I, James D Hughes, NMPE 11674, of the firm Mark Goodwin & Associates, hereby certify that the private portion of this project has been graded and will drain in substantial compliance with and in accordance with the design intent of the approved plan dated 1/19/04 (Except as noted below). The record information edited onto the original design document (circled as-built elevations) was obtained from Russ P. Hugg, NMPS 9750, of the firm Surv-tek Inc., and wall survey by Larry W. Madrano NMPS 11993 of the firm Precision Survey Inc. I further certify that I have personally visited the project site on 4/12/2005 and have determined by visual inspection that the survey data provided is representative of actual site conditions and is true and correct to the best of my knowledge and belief. This certification is submitted in support of a request for Release of Financial Guaranty.

TITLE: PARKWAY SUBDIVISION UNIT 10 GRADING AND DRAINAGE PLAN ENGINEERS CERTIFICATION

CITY PROJECT NO.	ZONE MAP NO.	SHEET	OF
DRB #1000570	J-9	1	2

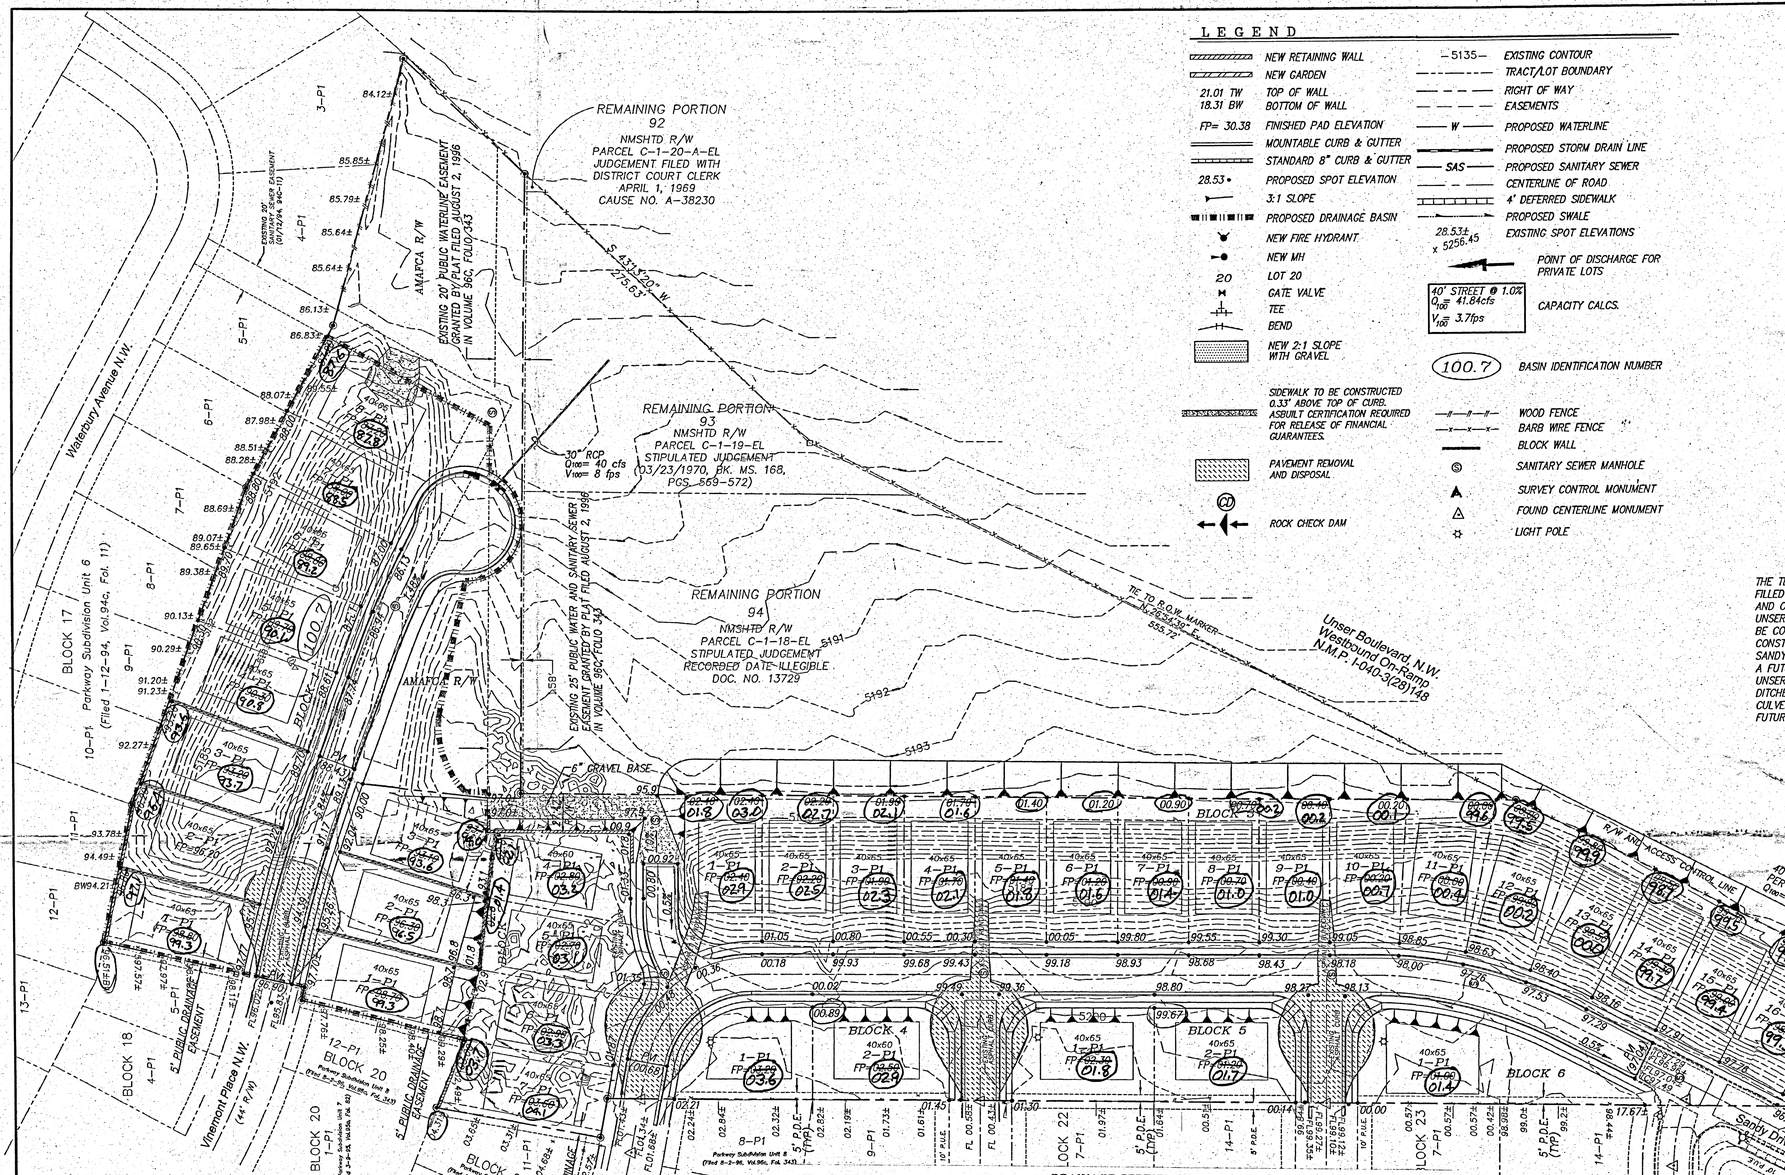
1. Rear yard grades on lots 4 thru 7 block 3 are lower than planed. The grades must be raised by Westland's wall builder so those lots drain to the street as planned.

1. The side yard swales were supposed to be separated by a 6" high dirt berm that is missing on most lots. So the drainage goes into a common swale on the low side of the lot line. It does not cause a problem now, but there is no private drainage easement for this "Common" and / or "Cross Lot" drainage.

2. Several of the lots had completed houses on them houses were under construction on others. All retaining walls and perimeter fence was complete.
3. All existing grades were found to be about 0.30' higher than shown on the plans, so all proposed grades were raised by 0.30'.

4. Front property corners were intentionally graded about one foot low to give the builder a place to dispose of excess dirt from the footers on the houses.

TITLE: PARKWAY SUBDIVISION UNIT 10
GRADING AND DRAINAGE PLAN
ENGINEER'S CERTIFICATION

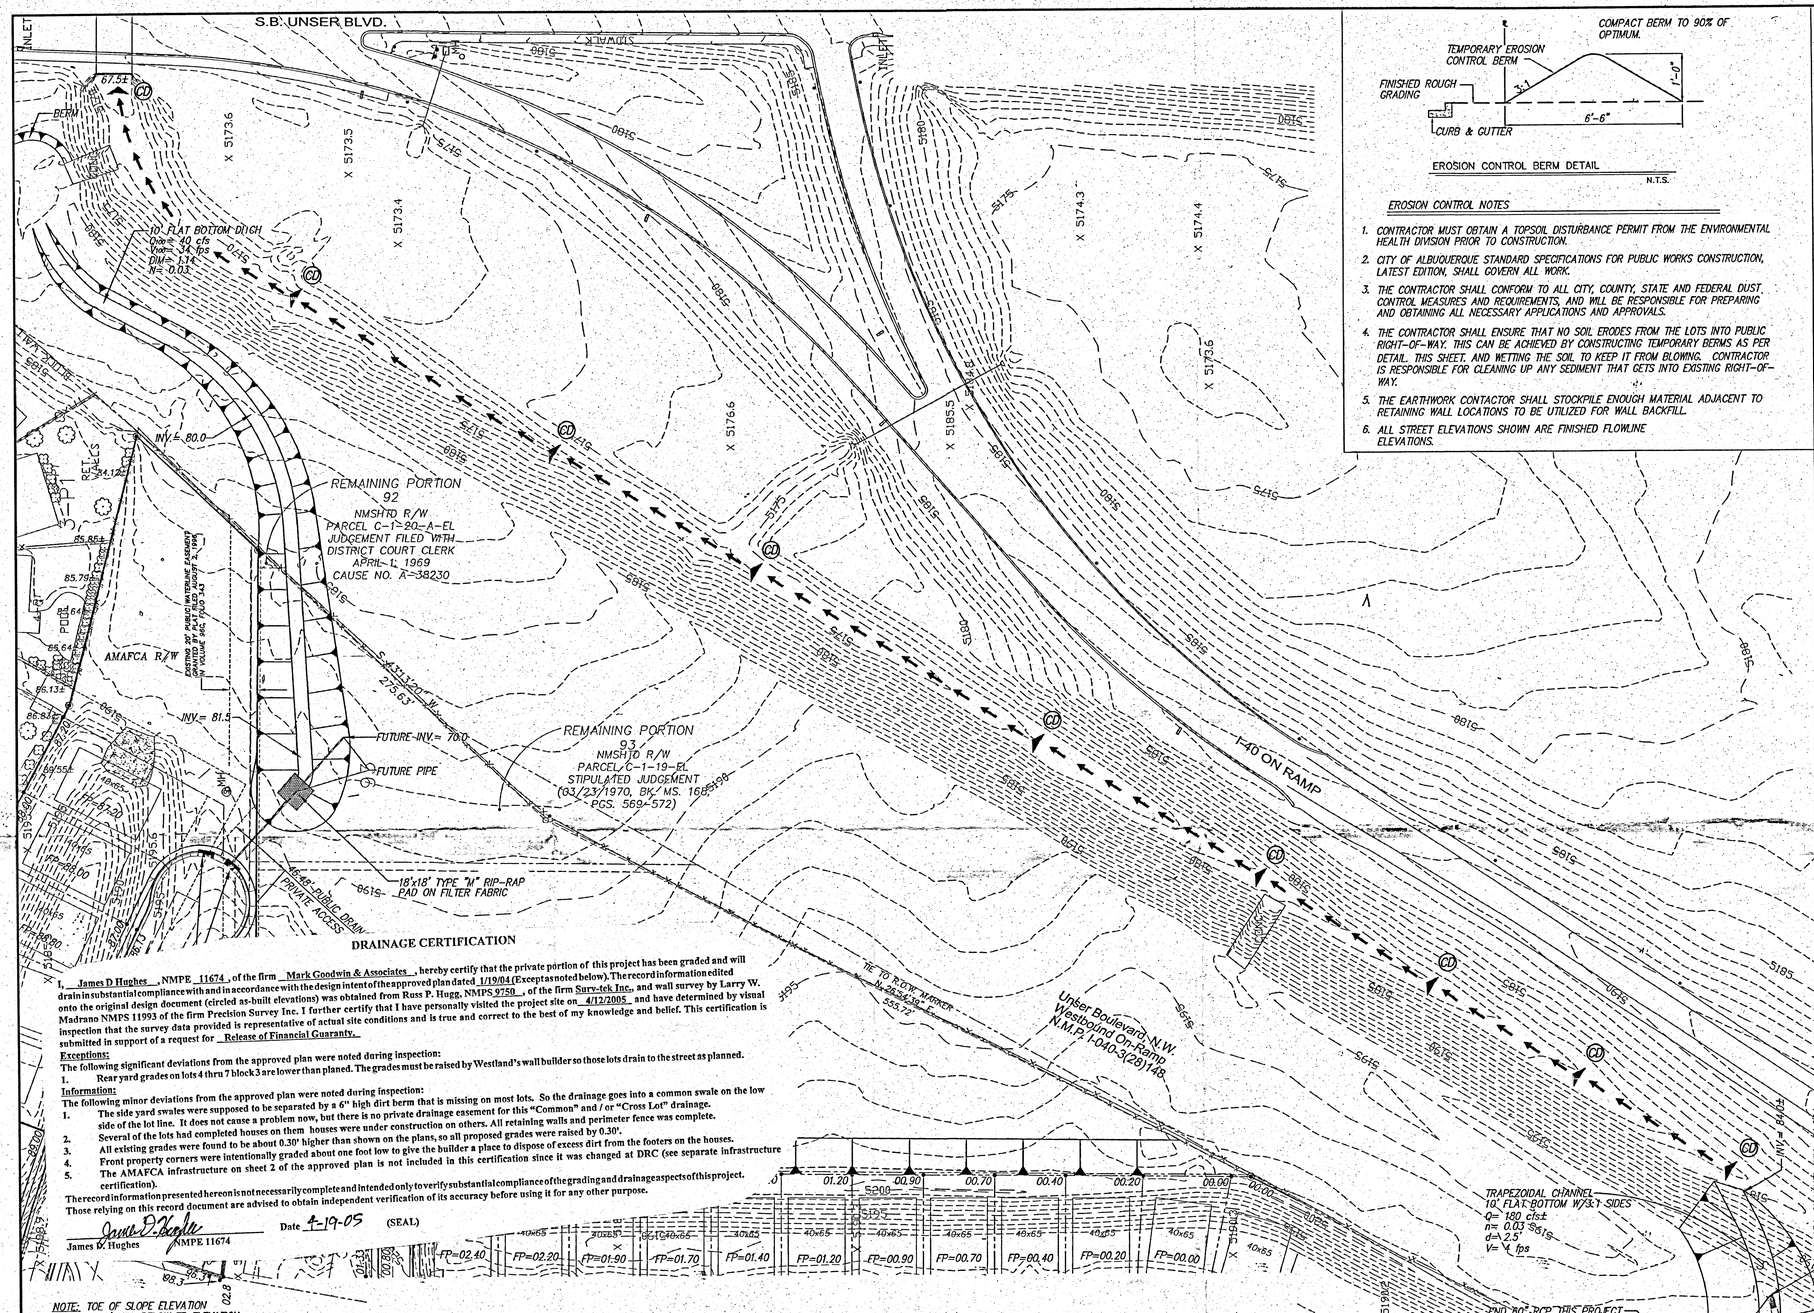
1. Rear yard grades on lots 4 thru 7 block 3 are lower than planed. The grades must be raised by Westland's wall builder so those lots drain to the street as planned.

1. The side yard swales were supposed to be separated by a 6" high dirt berm that is missing on most lots. So the drainage goes into a common swale on the low side of the lot line. It does not cause a problem now, but there is no private drainage easement for this "Common" and / or "Cross Lot" drainage.

2. Several of the lots had completed houses on them houses were under construction on others. All retaining walls and perimeter fence was complete.
3. All existing grades were found to be about 0.30' higher than shown on the plans, so all proposed grades were raised by 0.30'.

4. Front property corners were intentionally graded about one foot low to give the builder a place to dispose of excess dirt from the footers on the houses.

5. The AMAFCA infrastructure on sheet 2 of the approved plan is not included in this certification since it was changed at DRC (see separate infrastructure certification).
